# Tak Cheong licensing 1N4148 family Revision: 28 January 2015

**Self Qualification Report**

Information	Content	
Author	Kerstin Stolze	
Approver	Thomas Lange	
Supplier	NXP Semiconductors	
<b>Document Number</b>	PCN 201501003F01-GA15-01

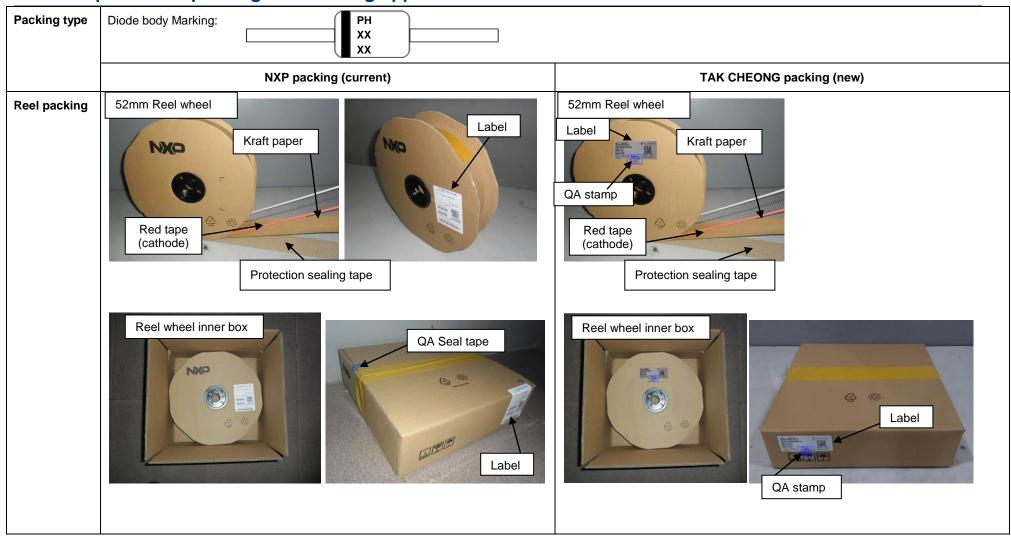
This change affects only the packing and labeling appearance.

Product marking, reel and box dimensions remain unchanged.

# 6. Comparison of packing and labeling appearance

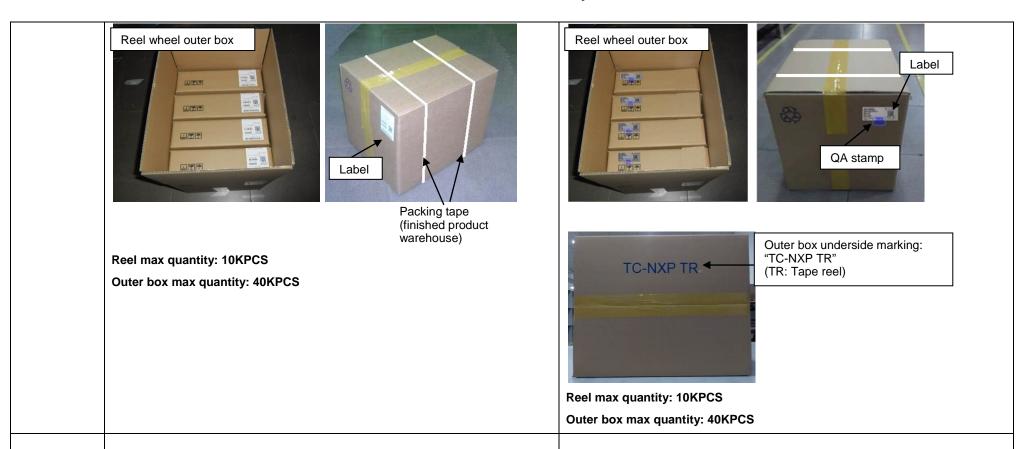
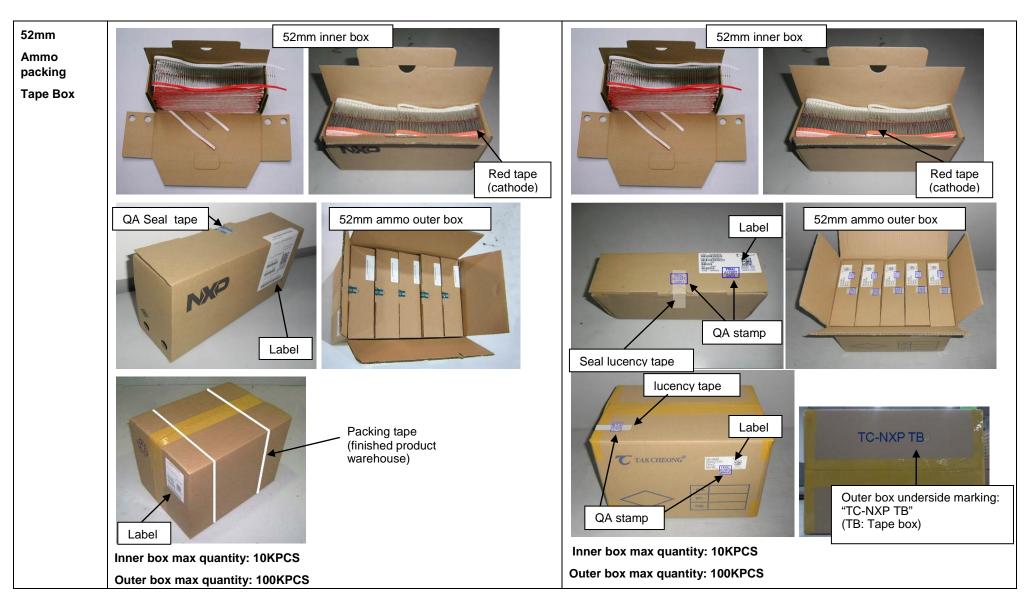
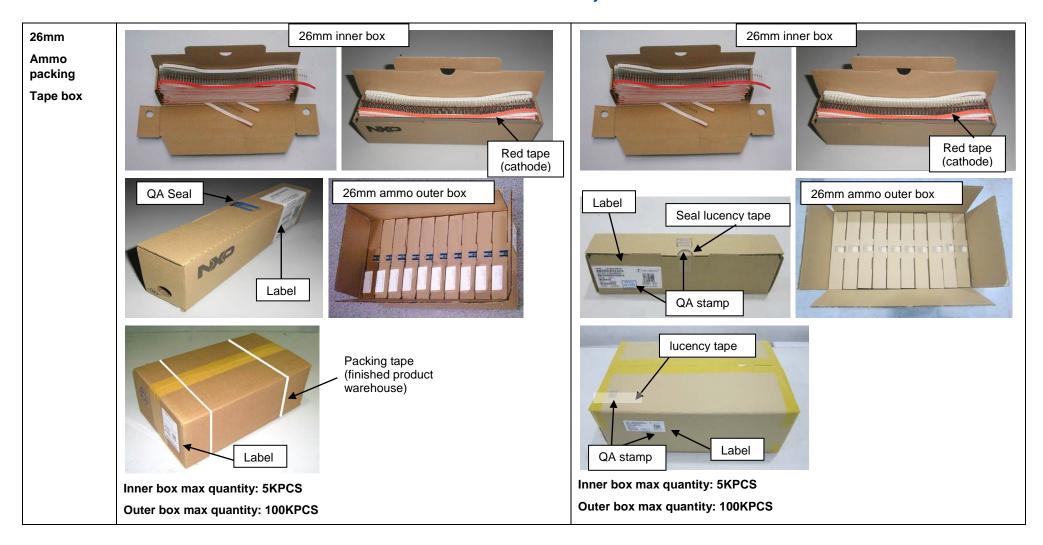
The change can be identified by the labels on the boxes and reels.
